Explanation

This document is the same as http://ieee802.org/3/bm/public/mmfnadhoc/meetings/jun12_14/802%203-95-TxVECImproved.pdf except the calculation is presented in a different way. The methods here and there are mathematically equivalent. Updated following the MMF ad hoc call, Thursday 26th June, 2014.

95.8.5 Transmitter vertical eye closure (TxVEC)

Figure 95–4—Illustration of the TxVEC measurement

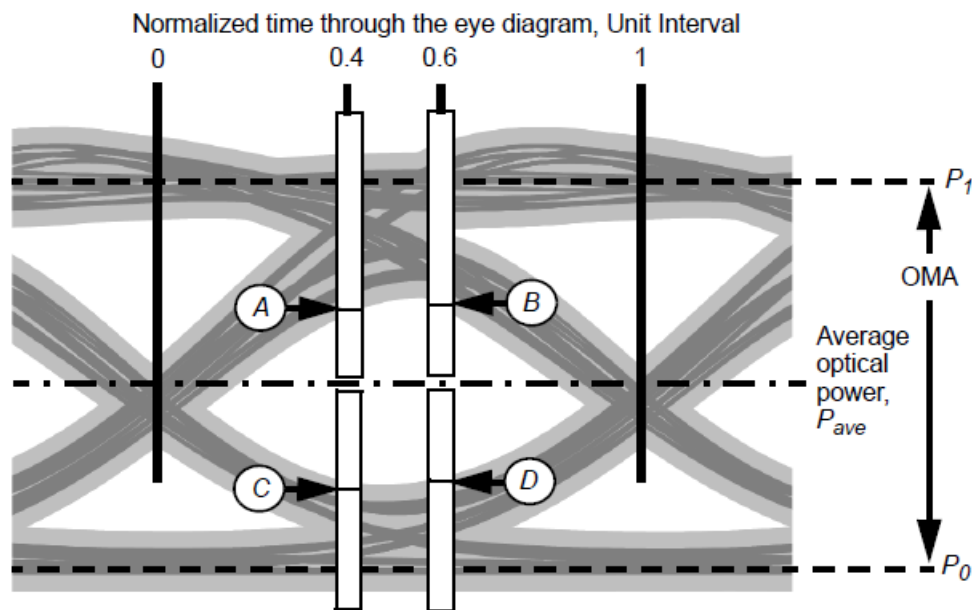
In Figure 95–4, delete the round labels and arrows A, B, C D. The values of P_1 and P_2 are not used in the calculation; they could be deleted if desired

P_1 P_0 [PD1] OMA ~~C-D-A-B~~
